DEVELOPMENT NO.:	24035929		
APPLICANT:	Joel Callander		
ADDRESS:	15 STURT ST GLENELG NORTH SA 5045		
NATURE OF DEVELOPMENT:	Two level residential flat building comprising 2 dwellings		
ZONING INFORMATION:	<ul> <li>Zones:</li> <li>Established Neighbourhood</li> <li>Overlays:</li> <li>Aircraft Noise Exposure</li> <li>Airport Building Heights (Regulated)</li> <li>Affordable Housing</li> </ul>		
	<ul> <li>Building Near Airfields</li> <li>Character Area</li> <li>Prescribed Wells Area</li> <li>Regulated and Significant Tree</li> <li>Stormwater Management</li> <li>Traffic Generating Development</li> <li>Urban Tree Canopy</li> <li>Technical Numeric Variations (TNVs):</li> <li>Minimum Frontage (Minimum frontage for a detached dwelling is 11m; semi-detached dwelling is 11m; row dwelling is 8m)</li> <li>Minimum Site Area (Minimum site area for a detached dwelling is 350 sqm; semi-detached dwelling is 300 sqm; row dwelling is 250 sqm)</li> <li>Maximum Building Height (Levels) (Maximum building</li> </ul>

# DETAILED DESCRIPTION OF PROPOSAL:

ITEM NO: 6.1 REPORT NUMBER: 135/24

### **Original Superseded Design:**

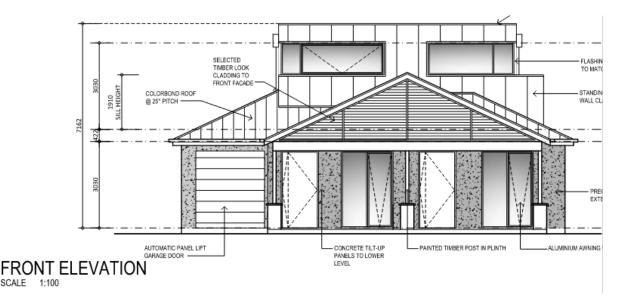
The applicant submitted a response to representations by way of amended plans (Attachment 1 – Application Documents), which demonstrate a revised built form aimed at addressing some of the concerns raised by both

planning staff and representors. The original plans reflected a building that had a 'boxed' form and failed to complement the surrounding built form character. To the applicant's credit, they considered the concerns raised and have altered the plans to reflect architecture that complements the prevailing built form character.

FRONT ELEVATION - STREETSCAPE

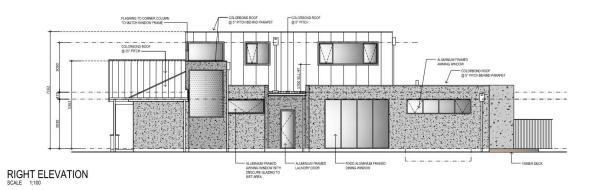
The proposed development is considered to align with the character area statement policies regarding anticipated architectural styles and the predominant built form character evident in Sturt and surrounding streets. Although the design incorporates two-level built form, the upper level is recessed behind the ground level facade by some 4.6 metres, is clad with the same material as the roof and is visually obstructed by the ground level gable roof fascia.

Although the ground level roof does not entirely obstruct the view of the upper level component, the overall design and siting of the upper level is such that the architecturally complementary ground level stands out as the visually dominant feature. The upper level would therefore visually fade into the background from a streetscape perspective.

When focusing on the visually prominent ground level component, the design complements the Glenelg North (West of Tapleys Hill Road) Character Area Statement in that it has been architecturally designed to comprise a 25 degree pitch gable iron roof with timber infills, rendered walls, vertically proportioned windows and doors, a good level of modulation and articulation and a simple building form. The front fence is a simple, 1.2 metre high plinth and pier fence with steel infills, which although does not include cast iron or wrought iron in a traditional arrangement, is reasonable on balance in the context with fencing currently found within the streetscape.

The garage is integrated within the main structure rather than being set to the rear or unobtrusively positioned to the side, making it a more visually dominant element that does not align with the area's prominent feature of garaging and carports being discreet and stepped behind the building facade. It is recognised that most modern dwellings are designed with garages under the main roof, aimed to convenience the occupants in terms of

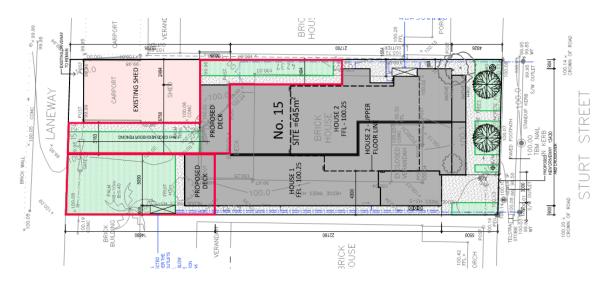
The building is setback 4.9 metres from the front boundary, which is complementary to the existing street setback pattern.

The building has ground level walls at a height of 3.2 metres setback a minimum of 900mm from the side boundaries and setback 14.6 metres from the rear boundary.

The building has upper level walls up to a height of 7.1 setback 1.65 to 2.4 metres from the northern side boundary and 4.3 metres from the southern side boundary. The upper level wall is setback 23 metres from the rear boundary.

The proposed boundary setbacks are considered to satisfactorily satisfy the relevant Performance Outcomes by way of ensuring natural light and ventilation to neighbouring properties.
